RE: Enbridge Sandpiper Pipeline PU-13-848

33 PU-13-848 Filed: 2/25/2014 Pages: 3
Exhibit Salmonson #1

ENBRIDGE PIPELINES (NORTH DAKOTA) LLC
PROPOSED SANDPIPER PIPELINE PROJECT
ROUTE MAP
Grand Forks County, ND
 DRAWN: MLB CHECKED: -
 DATE: Oct 16, 2012 SCALE: AS SHOWN
 Spread: 4 Map: 120 of 121

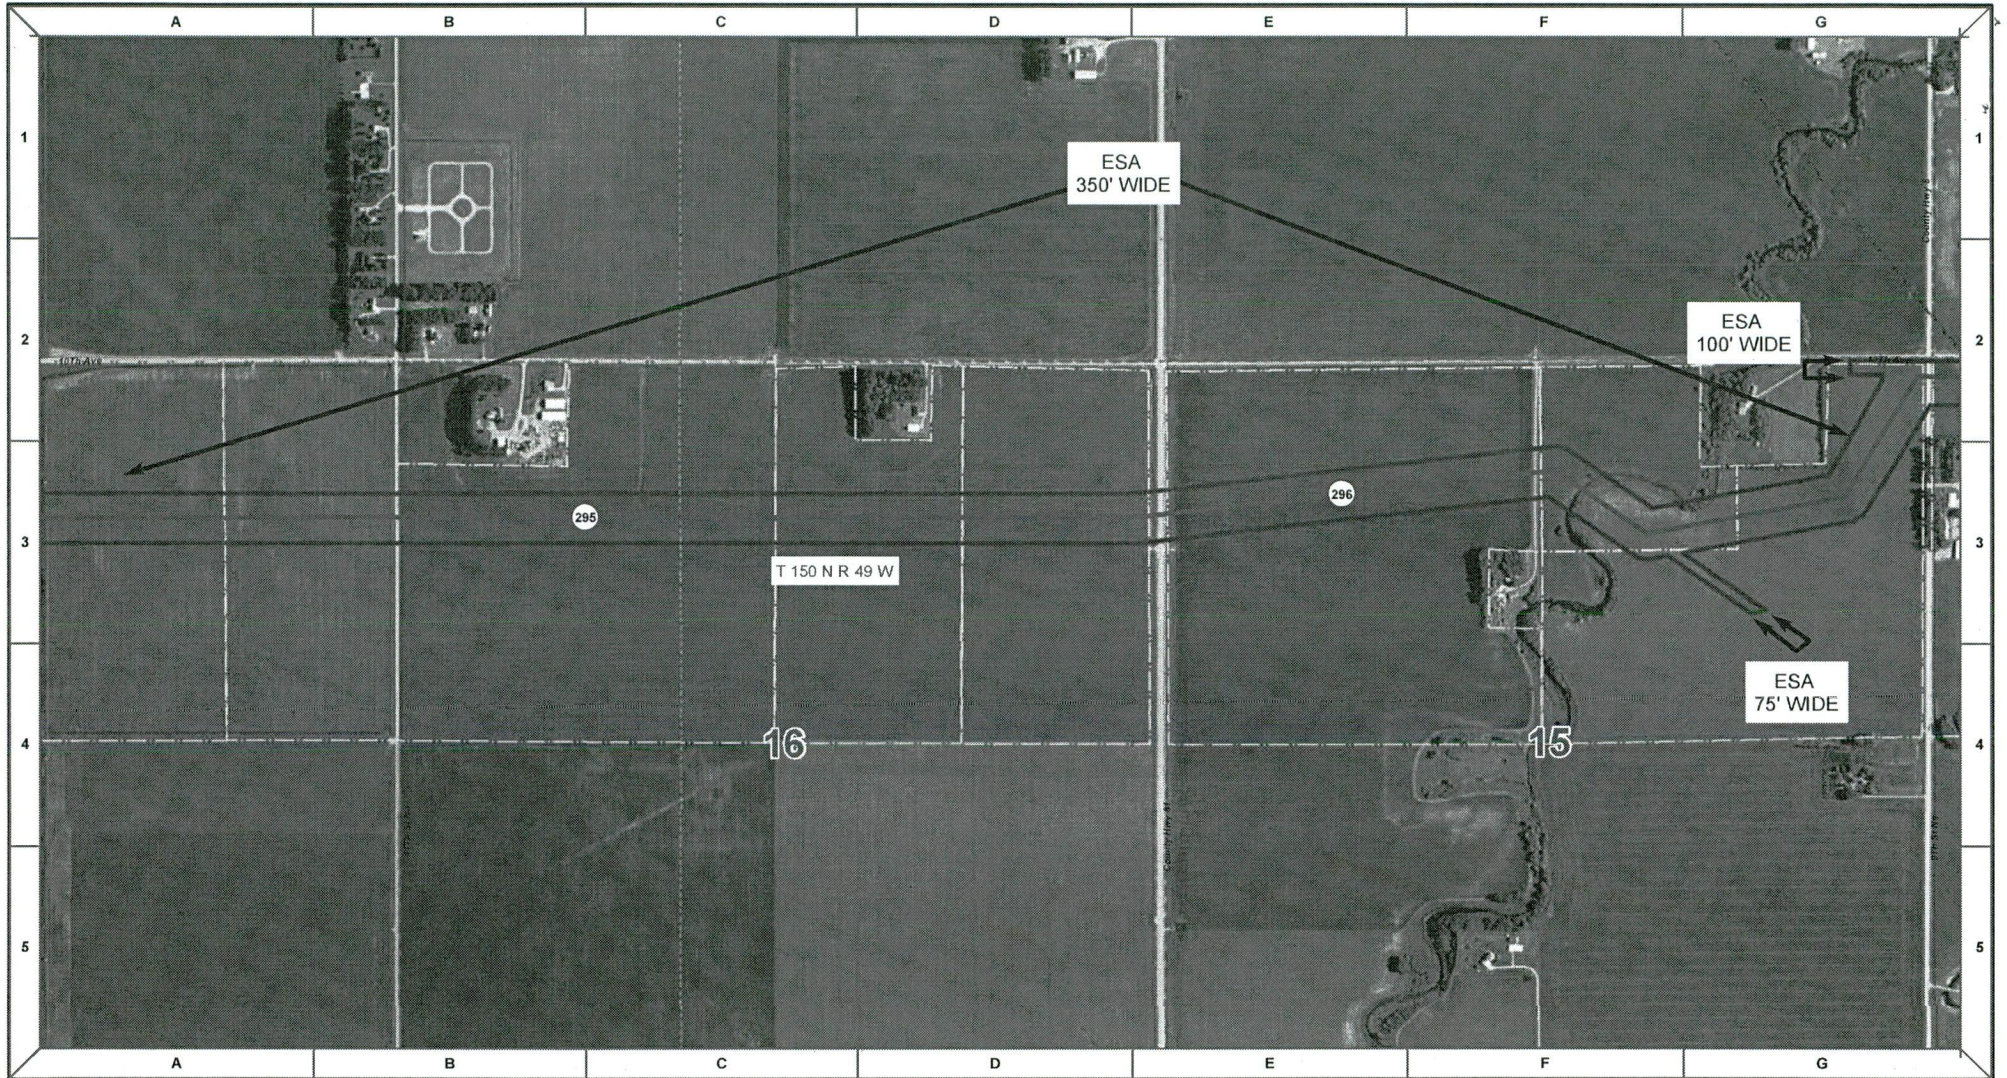
Due to deviating away from their existing right-of-way, the company is proposing to traverse my land located in section 15 of Walle Township. I have attached a copy for your reference. It is on page 252 of the siting document or map 120 of 121. In my opinion, the company has not adequately surveyed alternative routes to avoid my property and other properties along the route east of Interstate 29.

In the quarter section that I own, the company has proposed making four turns which would occur within one half mile.

1. The route does not follow any property line or other logical right-of-way such as a road. It zigzags in an effort to avoid a home. It does not take into consideration properties that would be future home sites. The pipeline will severely damage the value of those properties.
2. The sections, north of the property mentioned above, do not have any homes or home sites for more than 2 miles west of the point at which the proposed pipeline turns north. Use of these

sections, 9, 10, 11, and 12 would be more logical. It also reduces the number of turns the pipeline would require.

3. In a few years, due to the zigzag, no one will be able to determine the exact location of the pipeline because directional changes cannot be marked in the middle of the field. A farmer with a stuck tractor will most likely use a bulldozer to dig out the tractor. Imagine if the tractor is over the pipeline. The farmer is not likely to wait several hours, or days, for a locator to be dispatched when he is trying to get his crop planted or harvested. A stuck tractor is not uncommon in this area.
4. The pipeline is situated to cross the river at a point north of my property. It is illogical to situate the pipeline so far south just to turn north to cross the river. Again, the original right-of-way should be used.
